SEWAGE DISPOSAL SYSTEM

DEPARTMENT OF HEALTH AND MENTAL HYGIENE

SUBDIVISION Sand Hill Acres

Re: Septic System Installation
Sand Hill Acres Lot 9
2425 Sand Hill Road

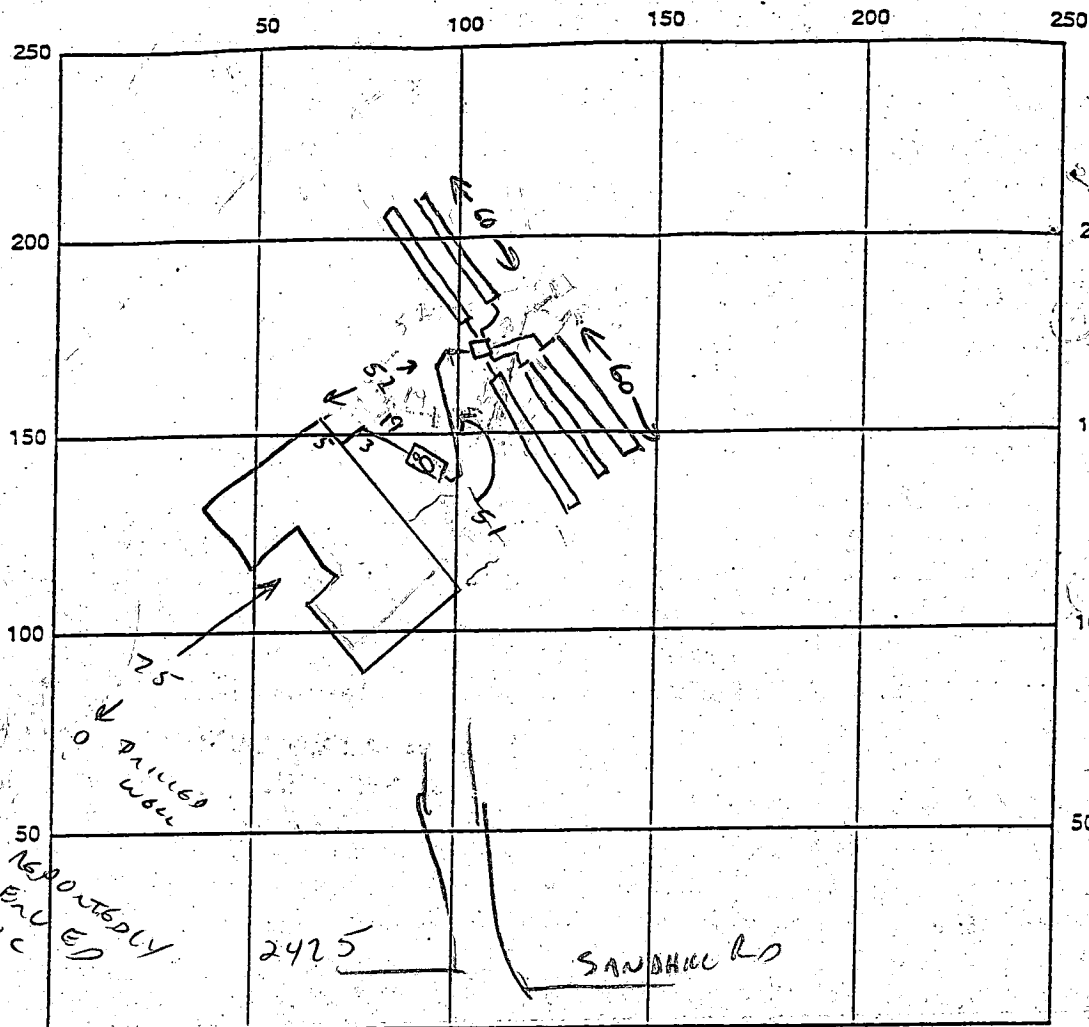
REMARKS: 9/15/99 HOUSE - TANK - DB - FIRST THREE TRENCHES COMPLETE;

SEVERE WEATHER IMMINENT. OK TO COMPLETE & COVER W/O FURTHER INSP. (C4)

(CONTRACTOR REQUESTED TO LEAVE LOCATION⁽³⁾ MARKERS AT BEND BEFORE DB,

AT DB, AND AT END OF UPPER LEFT TRENCH - LOCATION ISSUES TO BE RESOLVED)

- OWNER HAS INSTRUCTED ENGINEER TO PREPARE REQUESTED SURVEY DRAWING - PROVISIONAL APPROVAL

GRANTED. 12/30/99

LOCATION DRAWING
SAND HILL ACRES
LOT 9, SECTION 3, AREA 1
HOWARD COUNTY, MARYLAND

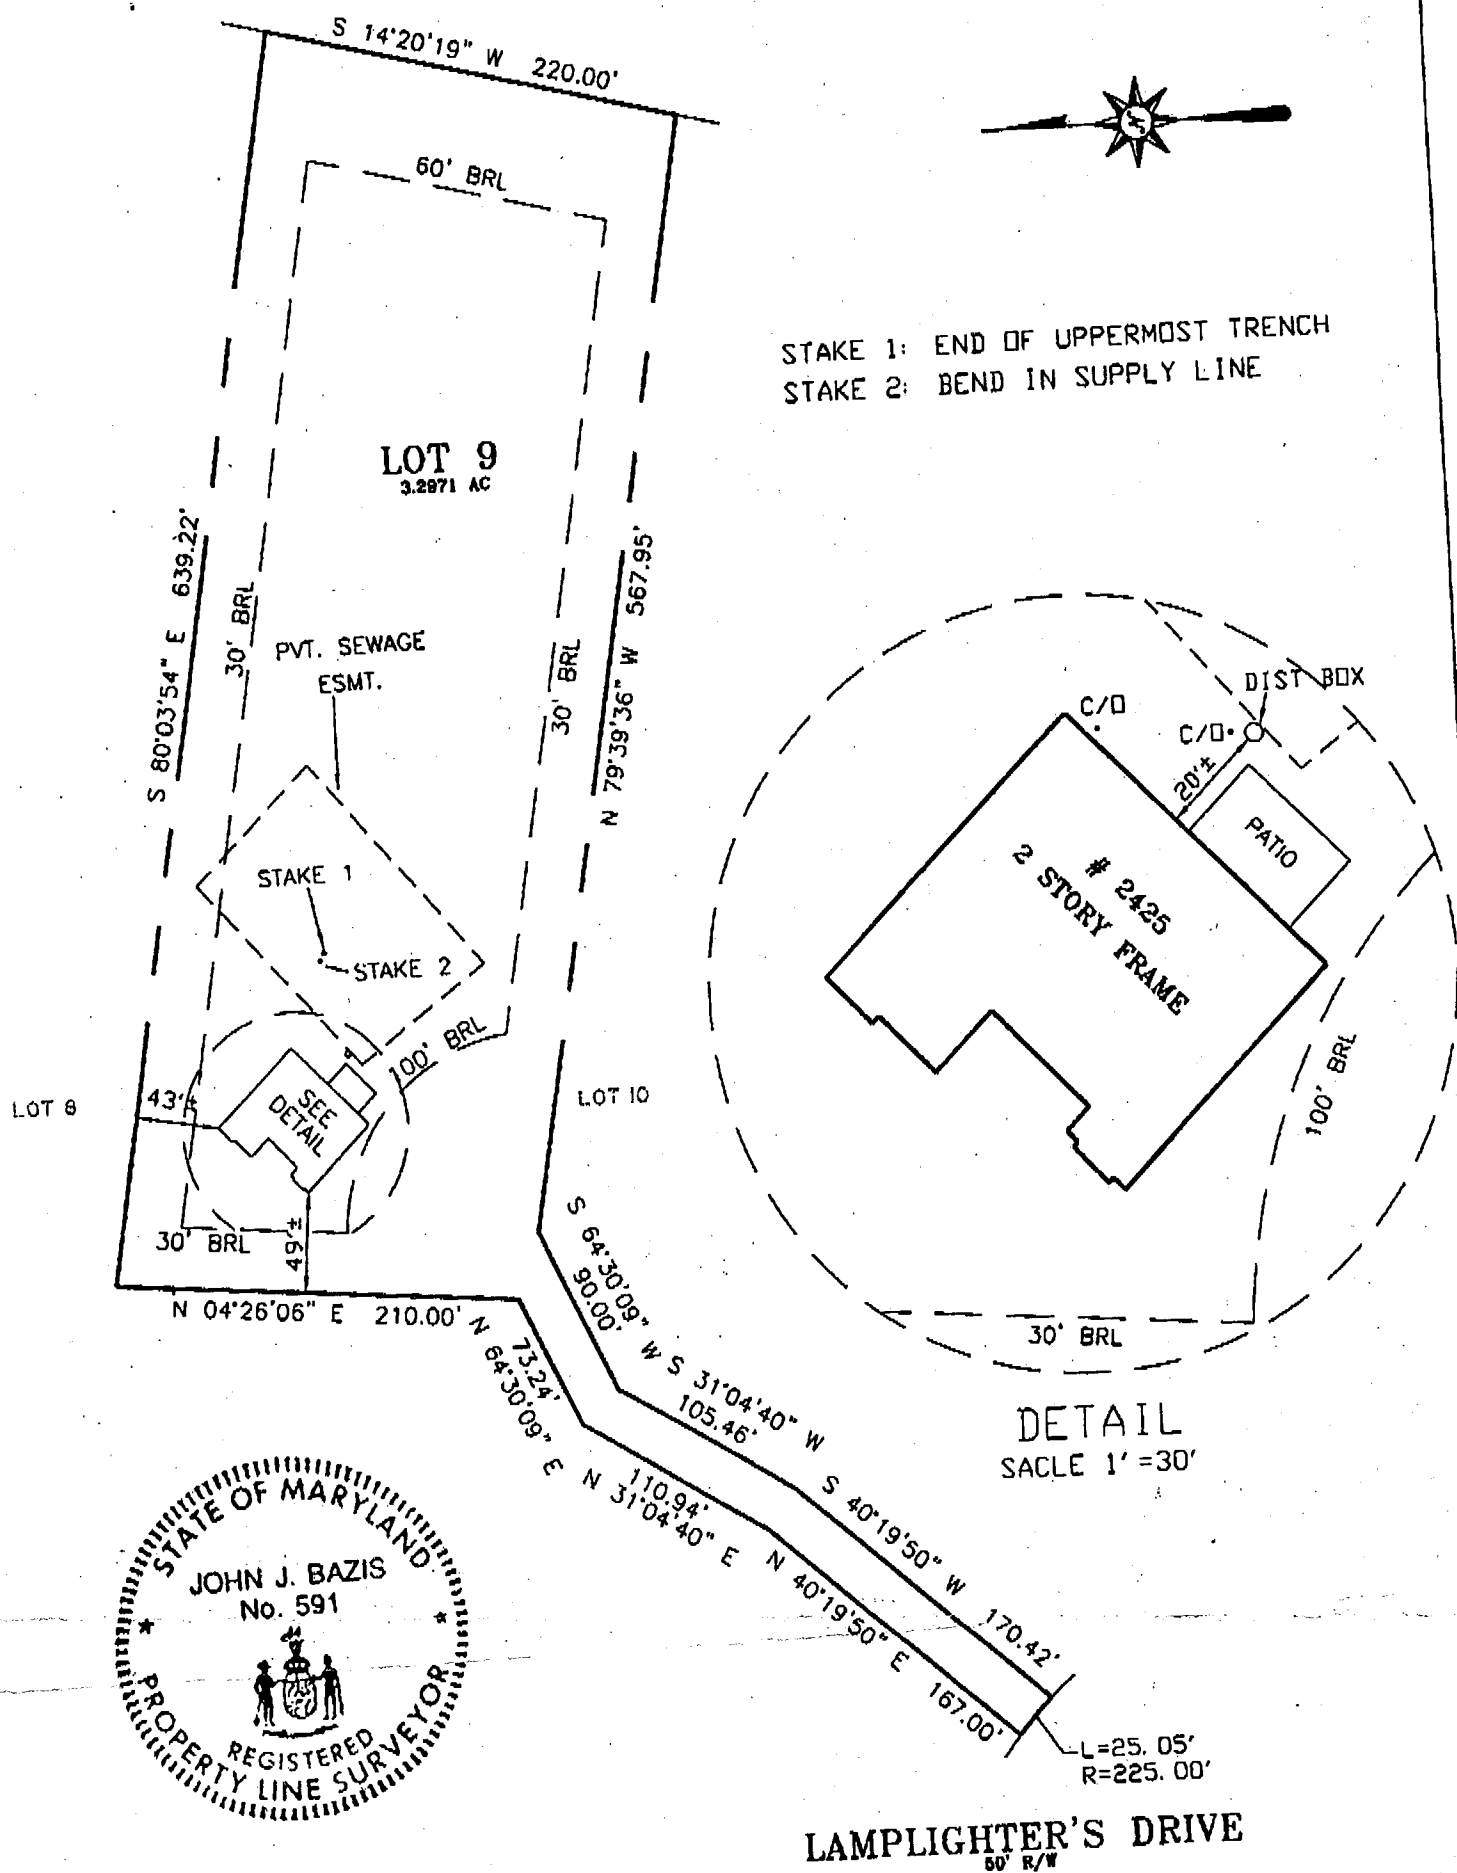
The septic system for the above referenced property was installed on September 15, 1999, but with some concern as to whether or not it is in the intended location. The installed system, as measured from lot boundaries, seemed to be 30' further back on the lot than intended; yet when measured from the house foundation, the system appeared to be in the correct location.

Submittal of a surveyed site plan showing the house footprint, the recorded sewage disposal area, and **critical points of the installed system**, is requested to confirm the correctness of the installed location.

note * - 4 critical points would be sufficient to to define the location of the installed sytem. First is the septic tank cleanout, then to the left of that and closest to the house is a stake which marks a bend in the supply line from the tank to the distribution box. Just below is another stake which marks the distribution box, and then to the left of that is a stake which marks the end of the uppermost trench.

DEC 30 UPDATE
VERBAL AGREEMENT
TO HOOK UP WELL
FOR NON-POTABLE IRRIGATION
SEE OCCUPANCY APPROVAL
LETTER, (CONDITIONS SET)
OF 12/30/99 (16)
